[Docket No. 94–NM–28–AD; Amendment 39–9292; AD 95–13–12]

Airworthiness Directives; Boeing Model 767 Series Airplanes Equipped With General Electric CF6–80C2 Series Engines

AGENCY: Federal Aviation Administration, DOT.
ACTION: Final rule.

95–13–12 Boeing: Amendment 39–9292. Docket 94–NM–28–AD. Supersedes AD 91–22–02, Amendment 39–8062.

Electro-Mechanical Brake and CDU Cone Brake Torque Check Figure 1

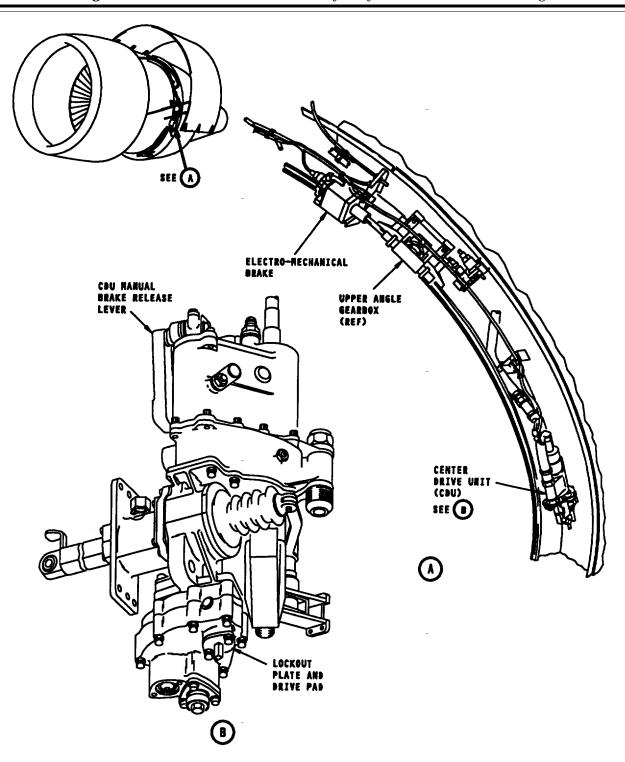
(d) Within 4,000 flight hours after accomplishing the modification required by paragraph (c) of this AD, or within 4,000 flight hours after the effective date of this AD, whichever occurs later; and thereafter at intervals not to exceed 4,000 flight hours; perform operational checks of the electro-

mechanical brake and the cone brake of the center drive unit in accordance with Appendix 1 (including Figure 1) of this AD.

- (e) Apply 90 pound-inches of torque to the system.
- (1) The electro-mechanical brake system is working correctly if the torque is reached before you turn the wrench 450 degrees (1-1/4 turns).
- (2) If the flexshaft turns more than 450 degrees before you reach the specified torque, you must replace the long flexshaft between the CDU and the upper angle gearbox.
- (3) If you do not get 90 pound-inches of torque, you must replace the electromechanical brake.

- (f) Release the torque by turning the wrench in the opposite direction until you read zero pound-inches.
- (1) If the wrench does not return to within 30 degrees of initial starting point, you must replace the long flexshaft between the CDU and upper angle gearbox.
 - (3) Fully retract the thrust reverser.
- C. Do a check of the torque of the CDU cone brake:
- (1) Pull up on the manual release handle to unlock the electro-mechanical brake.
- (2) Pull the manual brake release lever on the CDU to release the cone brake.

(6) Turn the torque wrench to try to manually extend the translating cowl until you get at least 15 pound-inches.

- (a) If the torque is less than 15 pound-inches, you must replace the CDU.
- D. Return the airplane to its usual condition:
- (1) Fully retract the thrust reverser.
- (2) Pull down on the manual release handle on the electro-mechanical brake until the handle fully engages the retaining clip.
